PRELIMINARY DOCUMENTATION RESPONSE: ADDENDUM 1

Citiswich - Stage 7

31 October 2024

Title: Preliminary Documentation Response: Addendum 1

FIGURE 1: SUMMARY OF THE MINOR REVISION TO THE DEVELOPMENT FOOTPRINT, INCLUDING UPDATES TO RETAINED AND REMOVED HABITAT FOR GHFF.

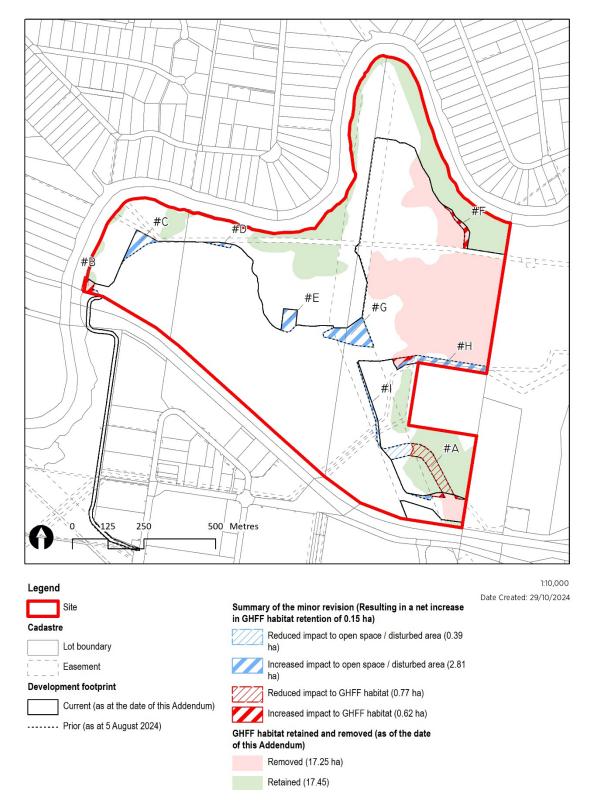
Item	Prior (as at 5 August 2024)	Current (as at the date of this Addendum)
Stage 7 Total Area	112.0 ha.	No change.
Nature of works	Subdivision of land into 20 industrial use lots and operation works to develop and service the industrial lots.	No change.
Development footprint	As per the Preliminary Documentation. Total proposed area: 70.0ha.	Total proposed area: 72.0 ha.
Impacts to native	Removed 17.4 ha.	Removed 17.25 ha.
vegetation communities (GHFF	Retained 17.3 ha.	Retained 17.45 ha.
foraging habitat, see Figure 1)		The minor revision results in a net increase in GHFF habitat retention of 0.15 ha and therefore provides a net benefit to the availability of foraging habitat on the site.
Offset Proposal and Offset Management	As per Preliminary Documentation.	No change.
Plan		Despite the increase in habitat retention, there is no change to the offset proposal, therefore, impacts are more than adequately offset.

New or altered edge effects	As per Preliminary Documentation (Figure 20) new or altered edge effects are approximately 1.5km.	A decrease of new or altered edge effects within GHFF foraging habitat by approximately 400m (27%) resulting in a reduction of perimeter-to-area ratio. This reduces the risk of indirect impacts and increases the resilience of retained foraging habitats.
Habitat fragmentation	As per Preliminary Documentation, an area of habitat is subdivided by a proposed road (see Area #A, Figure 1).	Retaining GHFF foraging habitat in Area #A reduces fragmentation by avoiding clearing and segmentation of a larger continuous patch of vegetation (see Figure 1). New areas removed are generally located into edge-effected or smaller vegetative patches (Areas #B and #H). This reduces the risk of indirect impacts and increases the resilience of retained foraging habitats.
Maturity of retained vegetation	As per the Preliminary Documentation.	The reduction in clearing of GHFF foraging habitat within Area #A will result in the retention of a larger number of mature trees which are more important GHFF foraging habitat than some exchange areas now proposed to be removed (Areas #B and #H).

Works description (refer to Figure 1 for map of locations A-I)	Requirements
#A Alternative Road Alignment	Geotechnical / Council Requirements Recent geotechnical investigations required a revision of design parameters for the entry road into the project. This has resulted in the northern entry road option no longer being required, reducing the proposed GHFF impact by approximately 0.77 ha (see Appendix 1). In order to achieve this, the remaining road entry required widening slightly to accommodate the increase in road level from RL18.7 to RL20.5.

#B Drainage Works	Council Requirements To comply with Council requirements and Operational Works approval to manage scour and erosion from the drainage channel.

#C Temp Detention Basin	Land Management / Council Requirements To manage any erosion and sediment during the earthworks, a temporary basin is required to ensure the site drains appropriately from the commencement of earthworks until the site is stabilised at completion. This is a council approval requirement.

#D Earthworks	Council Requirements The recent proposed changes to the Ipswich City planning scheme, which changed the Q100 flood level from RL18.7 to RL20.5, has created an additional footprint area. As a result, an increase in pad height means an increase in the embankment/batter extent.

#E Temp Detention Basin	Land Management / Council Requirements To manage any erosion and sediment during the earthworks, a second temporary basin is required to ensure the site drains appropriately from the commencement of earthworks until the site is stabilised at completion. This is a council approval requirement.

#F Earthworks	Council Requirements The recent proposed changes to the planning scheme, which changed the Q100 flood level from RL18.7 to RL20.5, has created an additional footprint area. As a result, an increase in pad height means an increase in the embankment/batter extent.

#G Earthworks	Council / Dept of Fisheries Requirements The recent proposed changes to the planning scheme, which changed the Q100 flood level from RL18.7 to RL20.5, has created an additional footprint area. As a result, an increase in pad height means an increase in the embankment/batter extent. Further information from the Department of Agriculture and Fisheries (Qld) regarding the culvert structure requirements for waterway barrier works resulted in additional treatment upstream and downstream of the structure.

#H Earthworks	Council Requirements The recent proposed changes to the planning scheme, which changed the Q100 flood level from RL18.7 to RL20.5, has created an additional footprint area.	
	As a result, an increase in pad height means an increase in the embankment/batter extent.	
#I Earthworks	Council / Dept of Fisheries Requirements	
	The recent proposed changes to the planning scheme, which changed the Q100 flood level from RL18.7 to RL20.5, has created an additional footprint area.	
	As a result, an increase in pad height means an increase in the embankment/batter extent.	
	Further information from the Department of Fisheries regarding the culvert structure requirements for waterway barrier works resulted in additional treatment upstream and downstream of the structure.
